RE: **10512 Redbud Residence**
10512 Redbud NW
Grading Plan
Engineer's Stamp Date 7/9/17 (File: A12D027)

RE: **10512 Redbud Residence**
10512 Redbud NW
Grading Plan
Engineer's Stamp Date 6/20/17 (File: A12D027)

Based upon the information provided in your submittal received 6/21/17, the Grading Plan cannot be approved for Building Permit until the following are addressed:

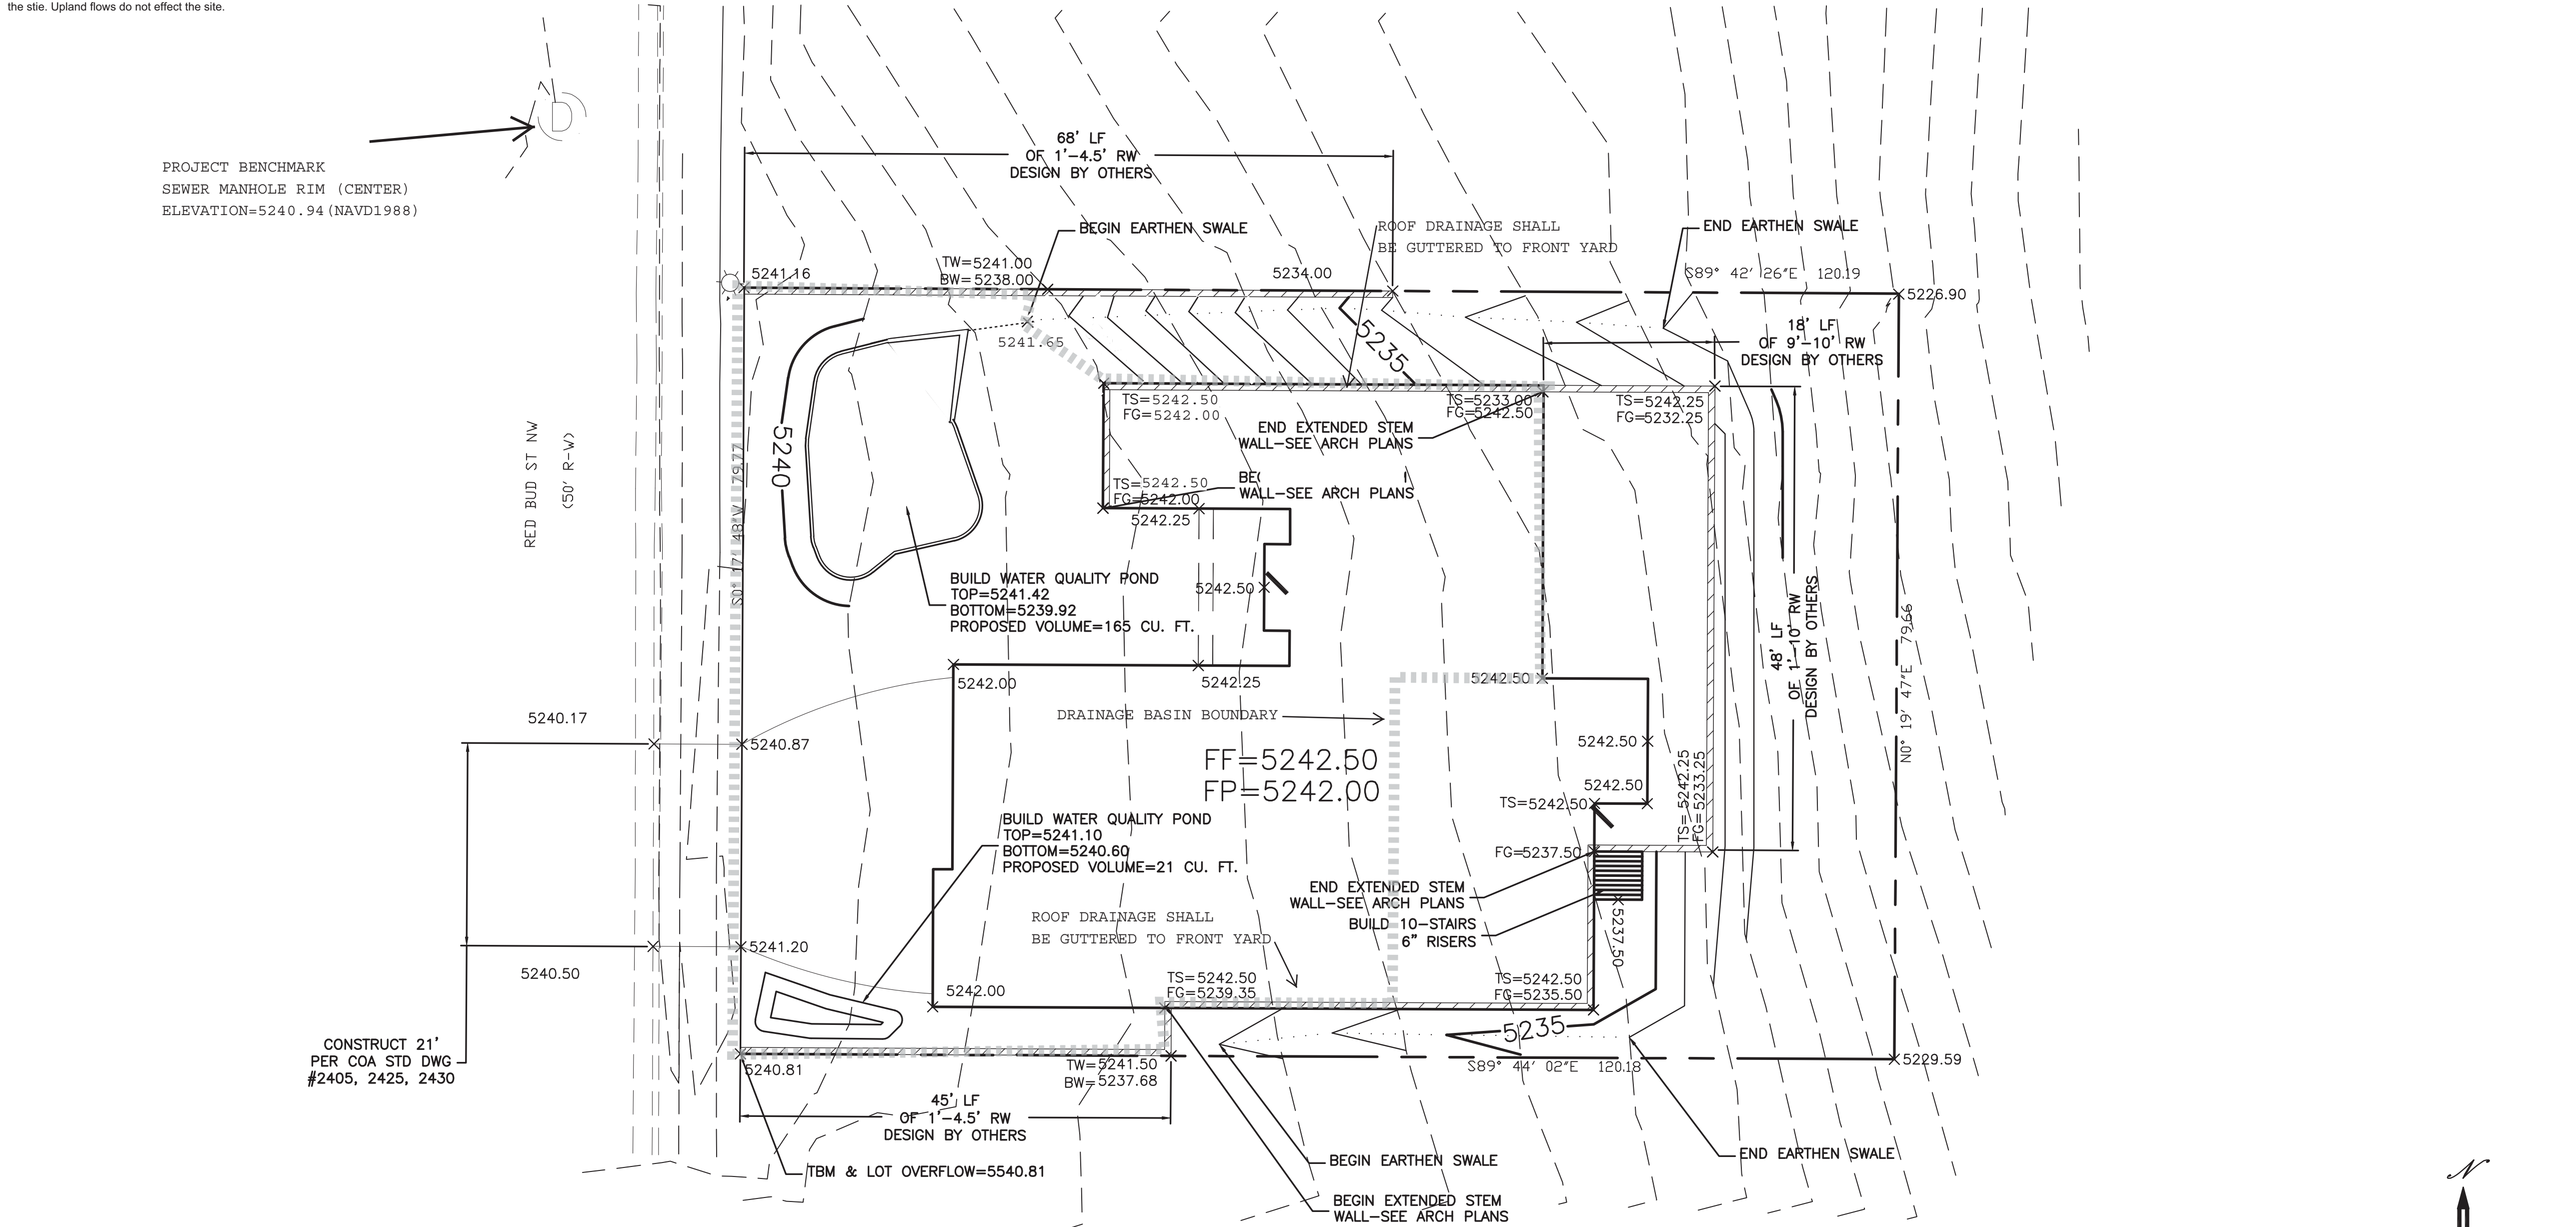
1. Show and calculate the sub-basin divide between the front of lot and back of lot. From the grading plan, it appears about half the site will drain west to the ROW and half to the east to an adjoining lot. **WE HAVE DELINIATED BASINS**
 2. For properties that historically drain to an adjoining lot, where the adjoining lot has an outfall, the adjoining lot should not see a change in peak flow. It appears the entire lot historically drained to the adjoining lot, therefore the proposed discharge to the back of this lot cannot exceed 0.38 cfs. This must be demonstrated on the plan. **WE HAVE SHOWN THEFRONT DISCHARGES .45 CFS AND REAR .27 CFS**
- If you have any questions, please contact me at 924-3695 or dpeterson@cabq.gov.
